- 5:40 2. [Certificate of Appropriateness Application](#)**
BAR 20-02-06
751 Park Street
Tax Parcel 520049000
Patrick Tennant, Owner
Jeff Dreyfus, Bushman Dreyfus Architects, Applicant
Side porch removal

**BAR MINUTES
CITY OF CHARLOTTESVILLE
BOARD OF ARCHITECTURAL REVIEW
Regular Meeting
August 18, 2020 – 5:30 p.m.
Zoom Webinar**

APPLICATION FOR CERTIFICATE OF APPROPRIATENESS

JANUARY 28, 2020 REVISED NOVEMBER 3, 2020

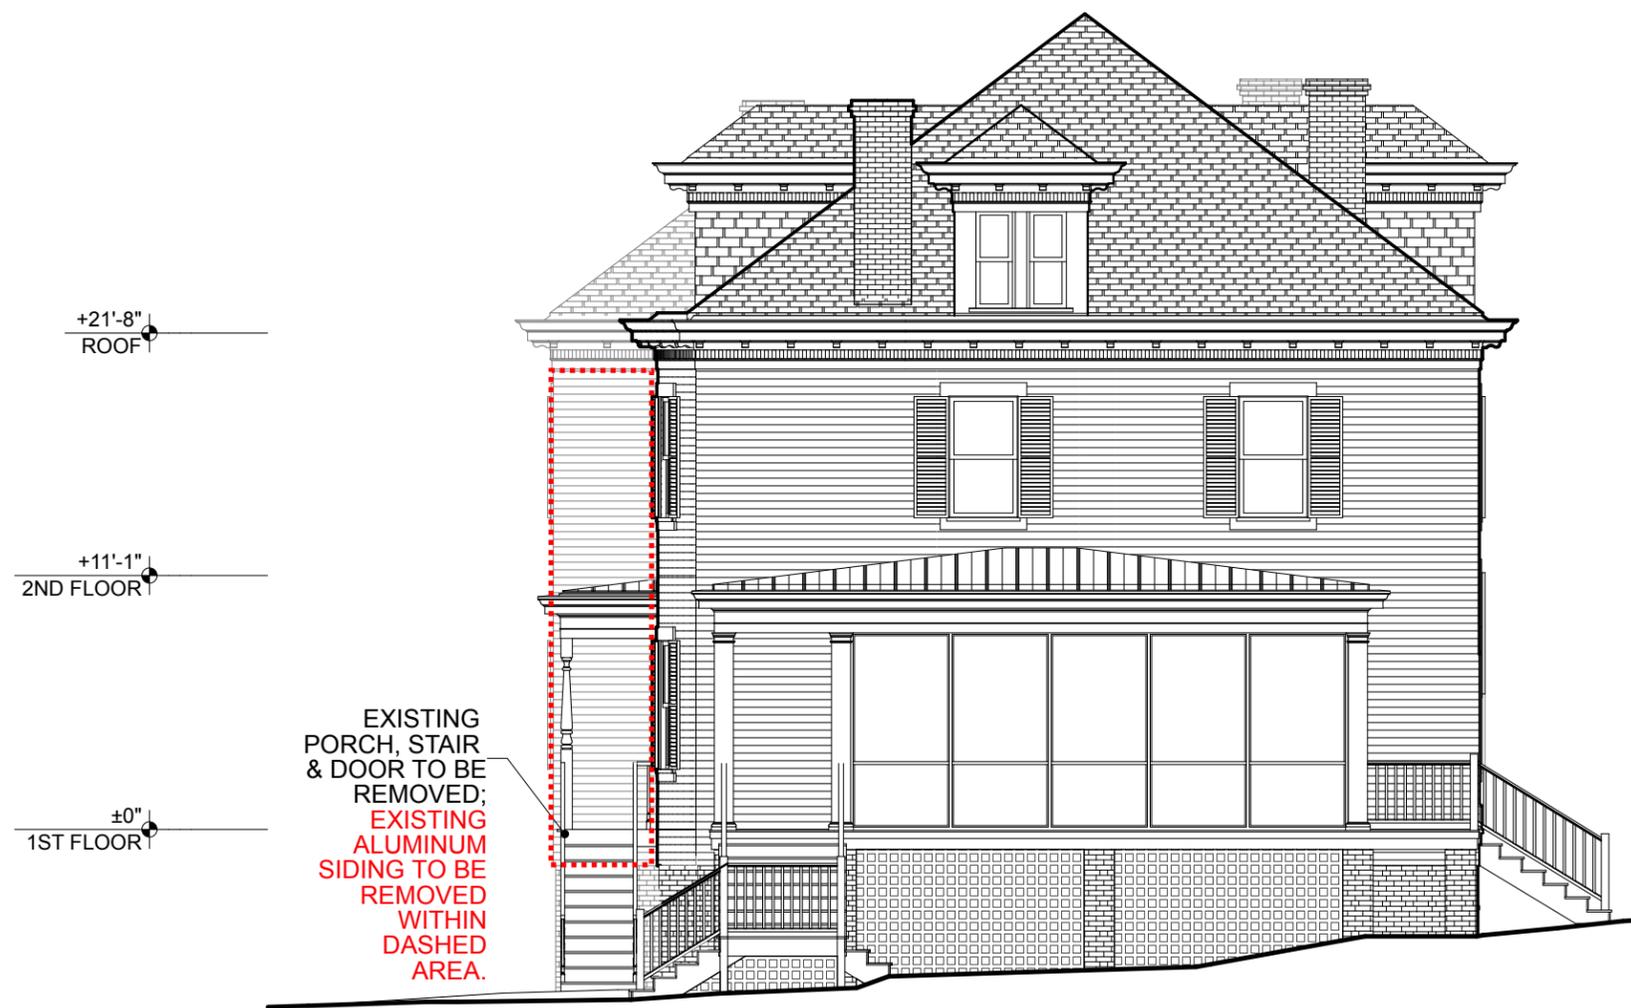
EXISTING PORCH,
 STAIR & DOOR TO
 BE REMOVED;
 EXISTING
 ALUMINUM SIDING
 TO BE REMOVED
 WITHIN DASHED
 AREA.

WHERE PORCH ROOF AND EAVE INTERSECT ALUMINUM-CLAD BOWED ELEVATION, SALVAGED ALUMINUM SIDING TO BE USED TO PATCHED HOLE IN EXISTING ALUMINUM SIDING.

EXISTING ALUMINUM SIDING TO BE REPLACED WITH PAINTED WOOD. EXISTING WOOD UNDER ALUMINUM TO BE SALVAGED IF POSSIBLE; OTHERWISE, NEW WOOD TO BE INSTALLED TO MATCH ORIGINAL 4" LAP. WOOD TO BE PAINTED TO MATCH ALUMINUM SIDING COLOR ON REMAINDER OF HOUSE.

NEW VINYL-CLAD WOOD WINDOW TO REPLACE DOOR. TRIM DETAILS TO MATCH EXISTING WINDOWS

EXISTING

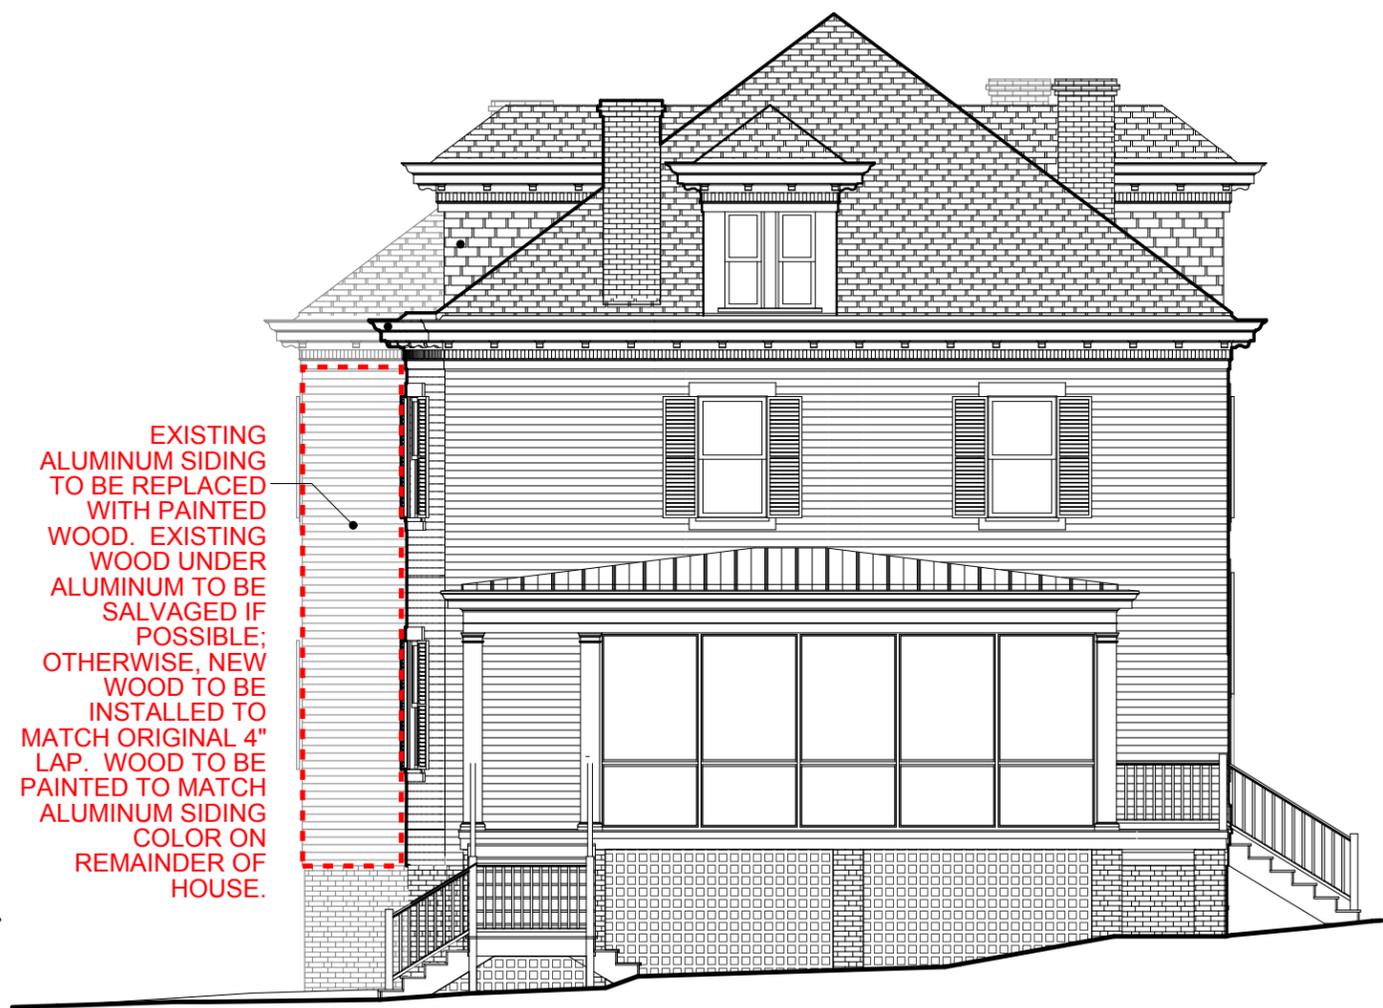
EXISTING PORCH, STAIR & DOOR TO BE REMOVED; EXISTING ALUMINUM SIDING TO BE REMOVED WITHIN DASHED AREA.

EXISTING ALUMINUM SIDING TO BE REPLACED WITH PAINTED WOOD. EXISTING WOOD UNDER ALUMINUM TO BE SALVAGED IF POSSIBLE; OTHERWISE, NEW WOOD TO BE INSTALLED TO MATCH ORIGINAL 4" LAP. WOOD TO BE PAINTED TO MATCH ALUMINUM COLOR ON REMAINDER OF HOUSE.

PROPOSED EXISTING OPENINGS TO BE RECONFIGURED

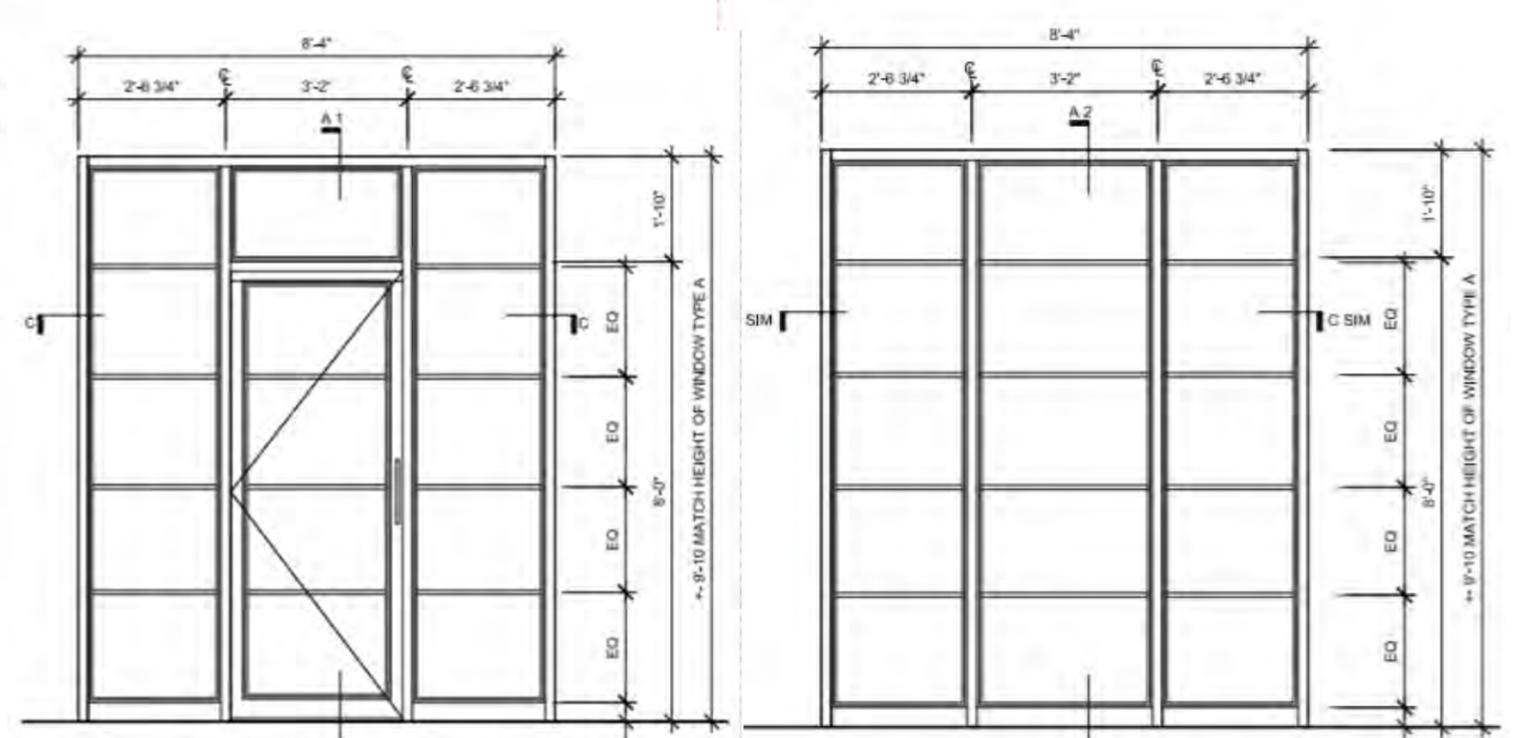
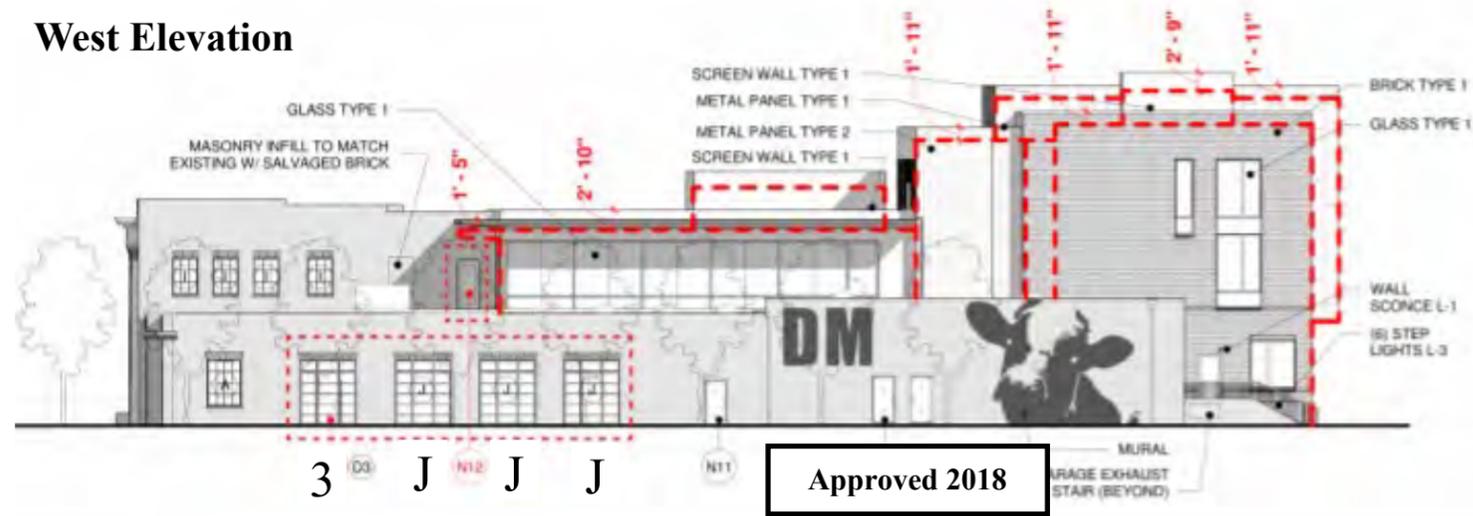
Proposed Change November 2020
